UNITED STATES PATENT AND TRADEMARK OFFICE

APPLICATION NO.	FILING DATE	FIRST NAMED INVENTOR	ATTORNEY DOCKET NO.	CONFIRMATION NO.
09/982,887	10/22/2001	Gunnar Flentje	7527	
7:	590 06/07/2005		EXAM	INER
Gunnar Flentje			JACOBSON, TONY M	
616 Holmby Avenue Los Angeles, CA 90024			ART UNIT	PAPER NUMBER
5 /			2644	
			DATE MAILED: 06/07/200:	5

Application No.	Applicant(s)			
Office Action Summary		09/982,887	FLENTJE, GUNNAR			
		Examiner	Art Unit			
		Tony M. Jacobson	2644 .			
The MAILING DATE of this communication appears on the cover sheet with the correspondence address Period for Reply						
THE - Exte after - If the - If NC - Failu Any	ORTENED STATUTORY PERIOD FOR REPL'MAILING DATE OF THIS COMMUNICATION. nsions of time may be available under the provisions of 37 CFR 1.1 SIX (6) MONTHS from the mailing date of this communication. period for reply specified above is less than thirty (30) days, a reply period for reply is specified above, the maximum statutory period or tre to reply within the set or extended period for reply will, by statute reply received by the Office later than three months after the mailing ed patent term adjustment. See 37 CFR 1.704(b).	36(a). In no event, how

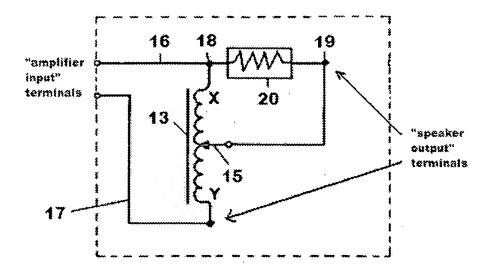
- (b) the invention was patented or described in a printed publication in this or a foreign country or in public use or on sale in this country, more than one year prior to the date of application for patent in the United States.
- 14. Claims 20, 21, and 25 are rejected under 35 U.S.C. 102(b) as being anticipated by Stefani et al. (US 3,160,841).
- 15. Regarding **claim 20**, Stefani et al. disclose in Fig. 1 a power attenuation circuit suitable for use with a musical amplifier and a speaker, comprising:

a variable autotransformer (10) having:

a coil (13) with a first coil terminal and a second coil terminal (inherently, at the ends of the toroidal winding [coil] 13, where leads 16 and 17 connect to the ends of the winding [coil] as described at column 3, lines 8-10); and

a variable coil tap having a first contact (15) in moveable electrical communication with the coil at a contact point (column 3, lines 5-8) and an output node (comprising 15, 19, 30, 31, 35), wherein the first contact (15) defines a first coil partition between the contact point and the first terminal and a second coil partition between the contact point and the second terminal (inherently);

a first "amplifier input" terminal (the end of lead 16, where it connects to a source of alternating current, as described at column 3, lines 8-10) in electrical communication with the first coil terminal (column 3, lines 8-10);

a second "amplifier input" terminal (the end of lead 17, where it connects to a source of alternating current, as described at column 3, lines 8-10) in electrical communication with the second coil terminal (column 3, lines 8-10);

a fixed resistor (20) in parallel electrical communication with the first coil partition (by means of the internal portion of lead 16, not illustrated); and

"speaker output" terminals (19 and an end of lead 17) in parallel electrical communication with the second coil partition and in series electrical communication with the fixed resistor (20).

Although Stefani et al. do not provide a complete electrical circuit diagram corresponding to Fig. 1, the description at column 2, line 69 –column 3, line 16 provides sufficient detail to deduce what is not explicitly shown in Fig. 1. An electrical circuit diagram showing the power attenuator circuit of Fig. 1 of Stefani et al. as described in the specification, based on Applicant's Fig. 2 is shown below to illustrate the correspondence to the limitations of claim 20.
